BUNDLED SOLAR POWER PROJECT BY D.J. MALPANI AND GIRIRAJ ENTERPRISES

Project Title	Bundled Solar Power Project by D.J. Malpani and Giriraj Enterprises
Version	01
Report ID	VKU.VER.16.22_VCS_1670

Report Title	Bundled Solar Power Project by D.J. Malpani and Giriraj Enterprises
Client	EKI Energy Services Limited
Pages	50

Variation of PLF in Tamil nadu from ex-ante estimation

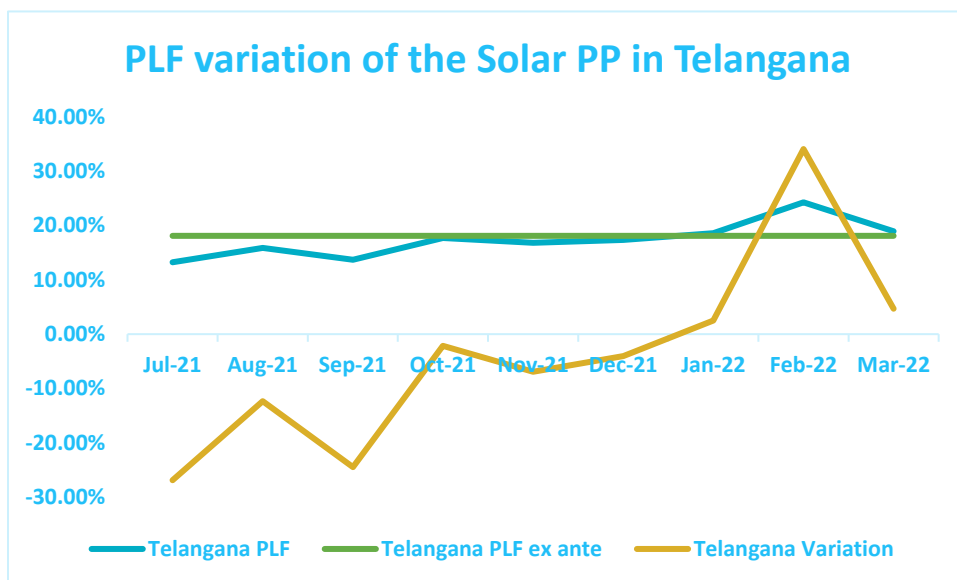
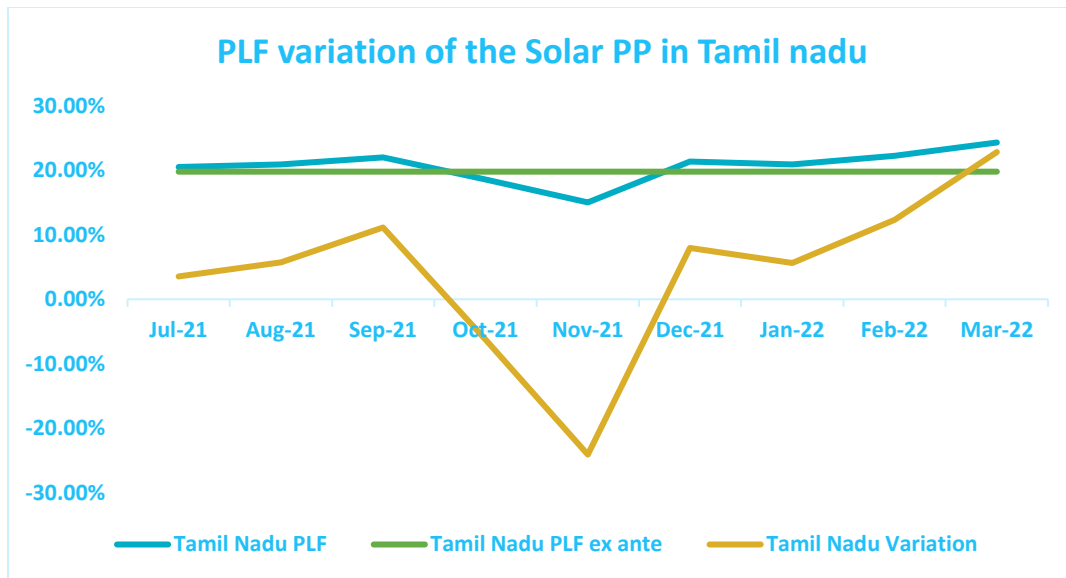
The assessment team further performed the analysis of the achieved PLF against the ex ante PLF and also the difference in PLF between the two. Further this was plotted in a graph and represented.

It can be seen that the net variation % has been positive for the site in Tamil nadu at +4.32% while it is negative for Telangana at -3.95%. So it can be seen that the PLF which is a function of the solar irradiation is fluctuating for different months with respect to ex ante PLF. However the net effect of the variation of PLF throughout the monitoring period is within +/- 5% from the ex ante PLF.
